Welsh Government
Consultation – summary of responses

A494 River Dee Bridge Improvement Scheme

September 2019

Figure 2.1: Overview of Option C

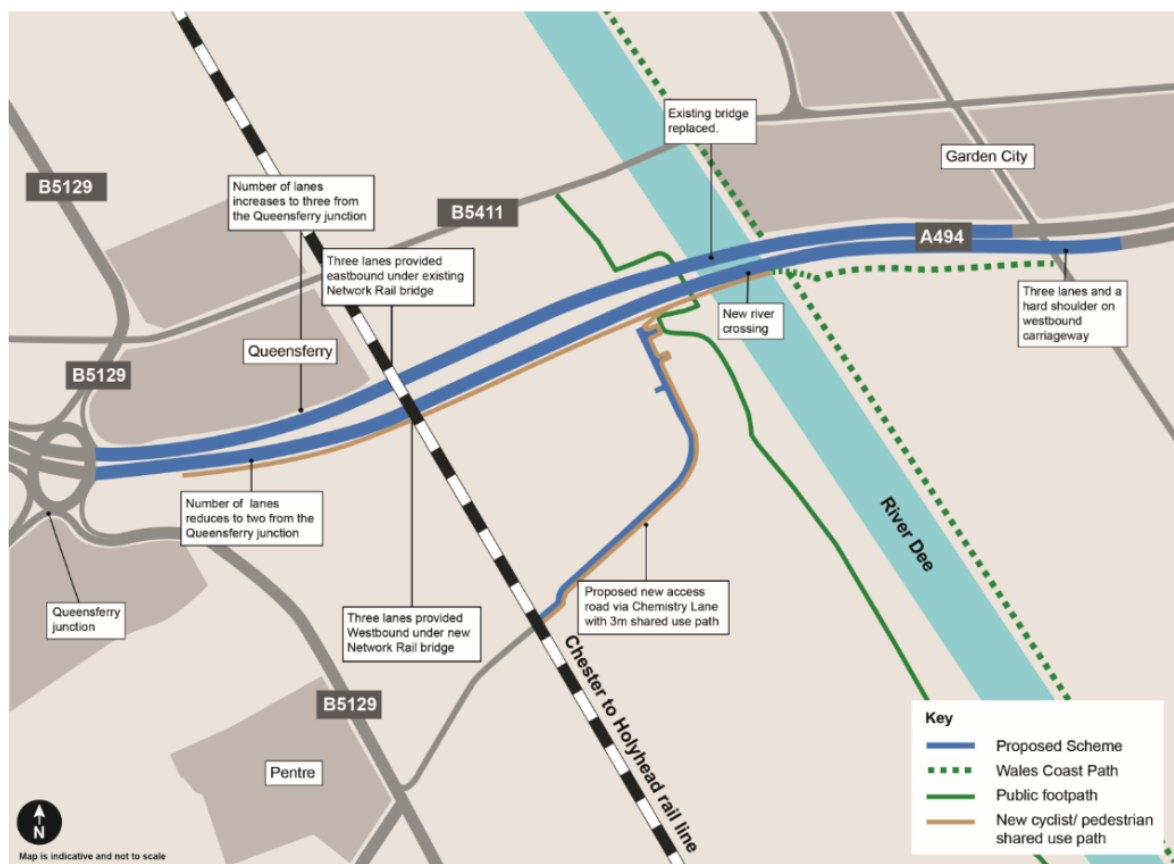
4.5.11 The Council has sought more information on the proposed road layout – specifically converging lanes on an existing congested route – as well as environmental and economic benefits of the scheme.

- The new shared use pathway on the south side of the new carriageway would have to pass through a very unpleasant chicane next to the main carriageway to negotiate the new North Wales Main Line railway bridge.

- The proposed new shared use pathway beside Chemistry Lane could be extended to Chester Road East to join the existing network. Cycling UK were unclear as to how this pathway would terminate at the river end and questioned some of the design details that were presented at the exhibition (e.g. junction crossings). Cycling UK were also not clear exactly what is proposed for NMUs on the south bank of the Dee.

- a. The alignment of the shared use path adjacent to the westbound carriageway has been reviewed to accommodate as smooth as possible transition for the path as it approaches and goes through the new railway underpass.
- b. Further clarification included to illustrate that the shared use path on both banks of the river will be improved where they pass under the new bridge structures.
- c. Agreement that further consideration will be given to extending the NMU provisions along Chemistry Lane as an on-road facility.
- d. Realignment of the junction where the shared use path diverges on the western side of the river bridge.

- e. Re-design of the connection of the shared use path to the existing paths on the eastern side of the river bridge, including the provision of an additional return ramp.
- f. Improving the existing path to Station Road on the western side of the river bridge, from the existing bridge / footpath 7 between the Toyota garage and the MoD Army Reserve Centre to Station Road (B5441). Proposals include new lighting, widening and re-surfacing of the existing path.
- g. Proposal for access stairs included to provide a direct route between the two paths on the western side of the river bridge.
- h. Resurfacing and improving the access path from Claremont Avenue to the Wales Coastal Path.
